**4R70E, 4R70W,  
4R75E, 4R75W  
Remanufactured  
Valve Body**

**Accumulator Plate Notice**

**F095**

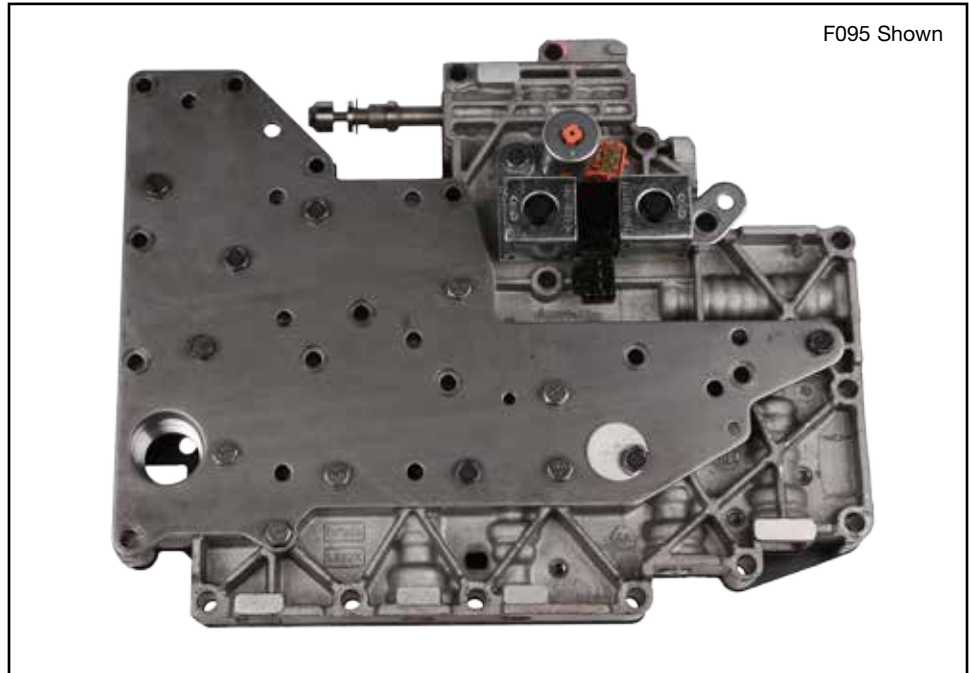
Sonnax '01-later 4R70E, 4R70W, 4R75E, 4R75W remanufactured valve bodies have three accumulator plates on the valve body. A 2-3 accumulator support plate is added during the remanufacturing process to eliminate separator plate cracking and cross-leaking.

Remanufactured valve bodies **F098** and **F095** are direct replacements. No modifications are needed as they completely interchange with the OE valve body.
